AGENDA
PLANNING AND ZONING COMMISSION MEETING
CITY OF CREVE COEUR, MISSOURI
TUESDAY, SEPTEMBER 6, 2016
6:30 PM

UNFINISHED BUSINESS**1. Application #16-023: Minor Site Development Plan Approval for Davita Parking Expansion at 400 N. Lindbergh Blvd.**

**APPLICATION TO PLANNING AND ZONING COMMISSION
#16-023: MINOR SITE DEVELOPMENT PLAN APPROVAL FOR DAVITA
PARKING EXPANSION AT 400 N. LINDBERGH BLVD.**

**APPLICATION TO PLANNING AND ZONING COMMISSION
#16-025 FOR A CONDITIONAL USE PERMIT AND SITE DEVELOPMENT
PLAN FOR EXTERIOR BUILDING IMPROVEMENTS FOR CONVERSION
TO A LOU FUSZ SUBARU FRANCHISE AT 900 NORTH LINDBERGH
BLVD.**

Figure 1: Close-up of the Revised Site Development Plan

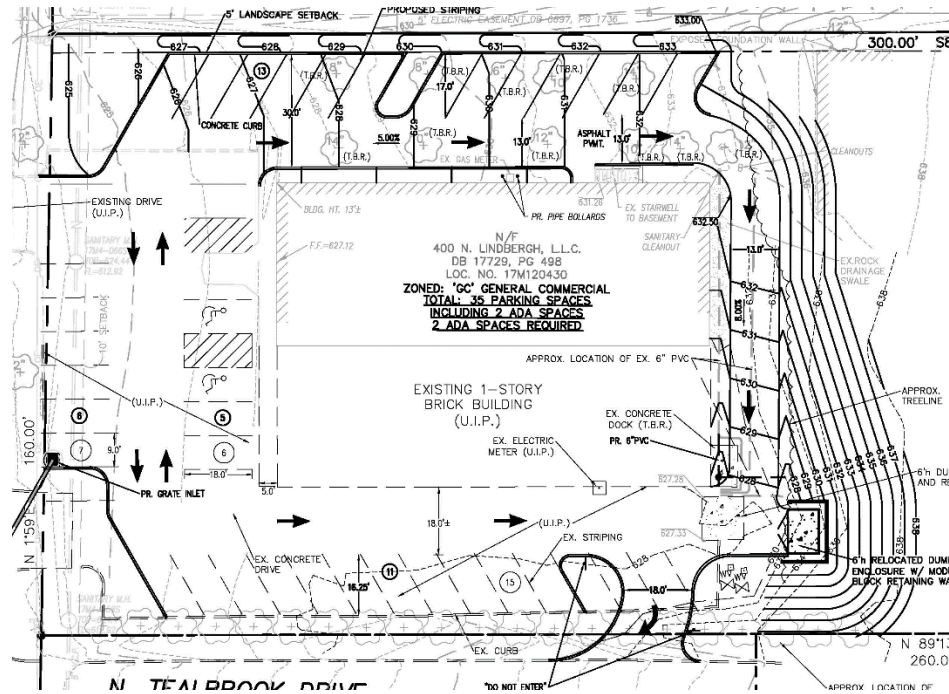
The Applicant has submitted revised drawings to address concerns regarding site circulation and landscaping that were discussed during the August 15th meeting. The proposal now includes eliminating the southern entrance along Lindbergh Boulevard, and creating a new exit only onto Tealwood Drive. Angled parking along the north side of the building and a new 13-foot wide, one-way access drive along the rear, and relocating the dumpster are now proposed. MoDOT has reviewed and provided initial approval of the new exit only, as well as providing for low landscaping along Lindbergh Boulevard to provide for headlight screening within MoDOT right-of-way. The layout provides for a total of 35 parking spaces. The new impervious surface created is 4,938 square feet, bringing the total site coverage up to 60.41%, where 63% is the maximum site coverage allowed.

Figure 2: Close-up of the Revised Landscape Plan.

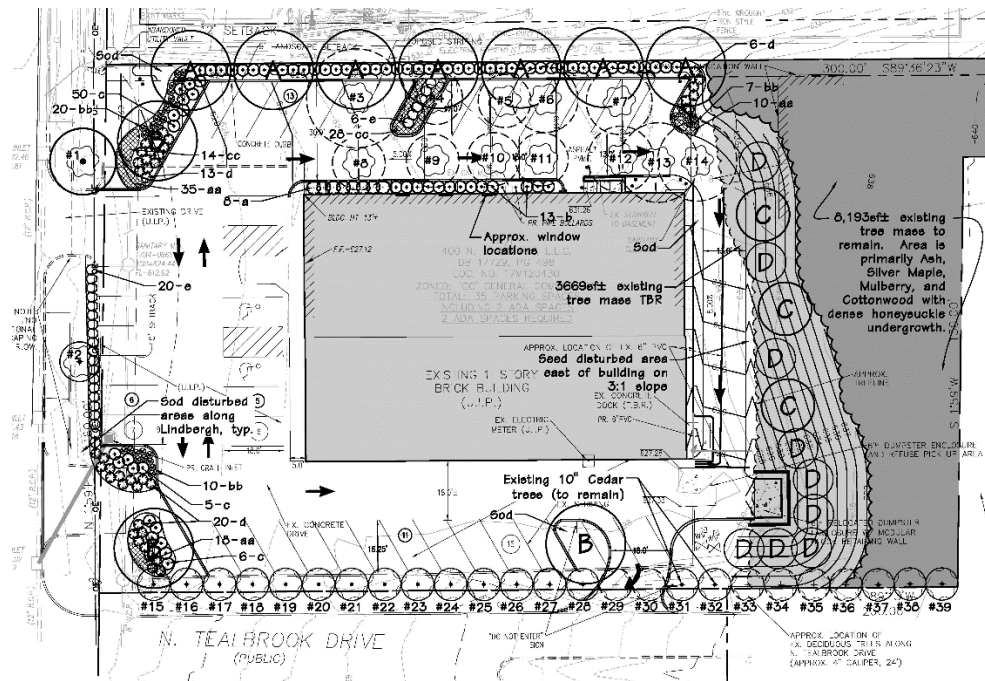
Additionally, Staff recommends that a few additional evergreen trees be added along the rear of the building for screening purposes where the spacing of the proposed trees are opened further than that to the south. Further, the code requires that all trees have a minimum 3 inch caliper, where the drawings indicate one of the type of trees is a 2 inch caliper. Therefore a condition of approval includes a revised Landscape Plan for additional evergreen planting and to meet with all of the requirements of Section 405.540 of the Zoning Ordinance.

Fill in with a few more evergreen trees to provide a continuous screen that is consistent with the plantings screening the trash enclosure

- The Landscape Plan shall be revised to provide for the additional evergreen trees along the new access drive to provide a continuous screen, and that all trees are a minimum of 3 inch caliper to meet with Section 405.540 Landscaping and with Design Guidelines for the Zoning Administrator's approval, and as discussed in the Staff Report on Application #16-023.

Figure 1: Close-up of the Site Development Plan

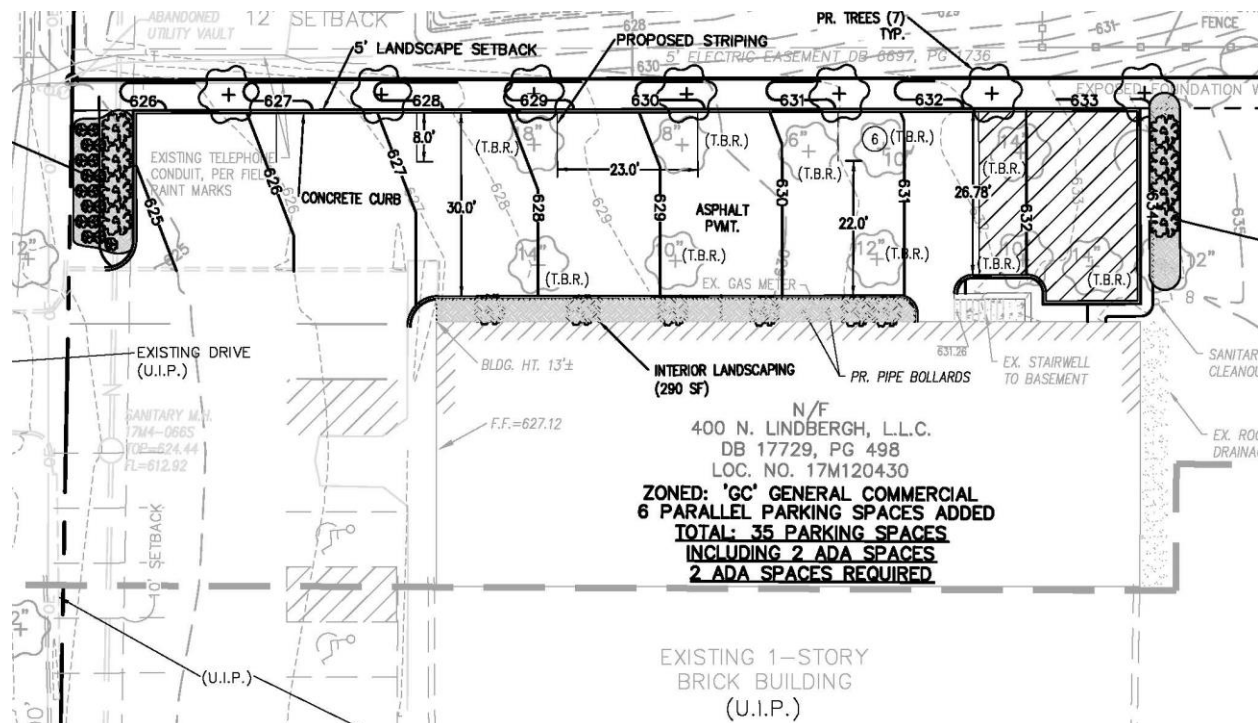
The site is already difficult to navigate with limited turnaround ability on the south end of the building. Staff has a concern that the proposed addition parking layout that requires a 5 point turn only exacerbates the problem further on this site. Staff has suggested exploring cross-access with the property to the north and shared parking as well as eliminating the southernmost entrance to provide for additional parking along Lindbergh, as alternatives. Another alternative would be to provide an access drive around the rear of the building which would allow vehicles to exit the site without turning around and reworking the existing parking lot layout to bring into closer conformance with the landscaping requirements. While, this option would require additional tree removal and would impact the resident to the east and also create site coverage limitations that would have to be addressed, the circulation would be markedly improved. The Commission members should discuss these options with the applicant during the meeting.

Staff believes that the proposed layout is problematic requiring vehicles to turnaround using a multi-point turning movement to exit the site. A similar condition exists on the south side of the building within the existing parking lot. Staff would prefer the inclusion of an access drive behind the building to address the existing and proposed circulation issues on this site. With these concerns present, staff would recommend that the application be continued to the next meeting to allow the applicant to revise the proposal.

1. The Landscape Plan shall be amended to provide additional landscaping along Lindbergh Boulevard, to meet with the requirements of Section 405.540 Landscaping and Section 405.810 Off-Street Parking and Loading Regulations.

Figure 8: Close-up of the Landscape Plan showing the portion along Olive Boulevard interchange.

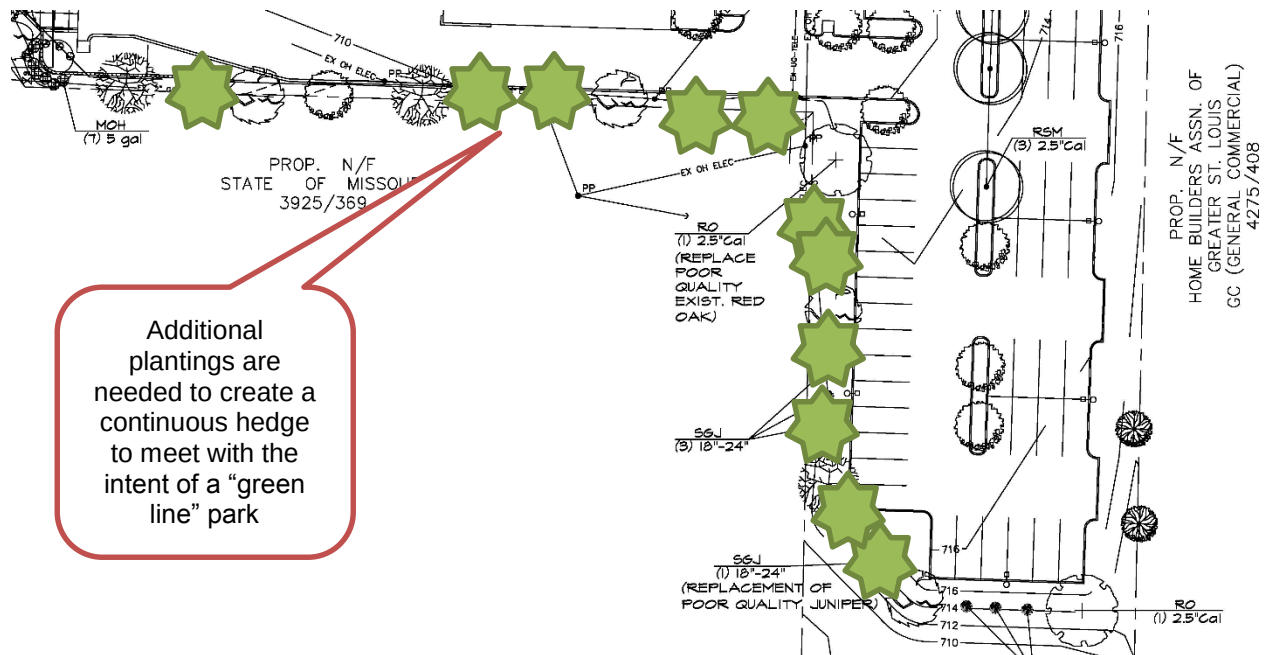
However, as discussed above, the spacing of the low shrubs is too far apart, where Section 405.540(F)(7) of the Landscaping requires that no landscaped hedge shall be less than two (2) feet in height and two (2) feet in spread at time of installation and that the individual plants used in the development of such a hedge shall be placed so as to be not more than thirty (30) inches on center. As this area is limited in width, MoDOT has indicated that the plantings of low shrubs in the right-of-way may be provided.

Further, the code requires that all trees have a minimum 3 inch caliper, where the drawings indicate trees at 2.5 inch and 2 inch caliper. [Additionally, Section 405.810(A)(5) of the Off-Street Parking and Loading Regulations requires that all parking adjoining a residential use or public right-of-way, except for those associated with single-family and two-family residences, shall be screened from view by an earth berm, solid wall, decorative fence, evergreen planting of equivalent visual density or other effective means of a minimum of 18 inches, and an average of three feet in height.] Therefore a condition of approval includes a revised Landscape Plan for additional evergreen planting and to meet with all of the requirements of Section 405.540 of the Zoning Ordinance for the Zoning Administrator's approval.
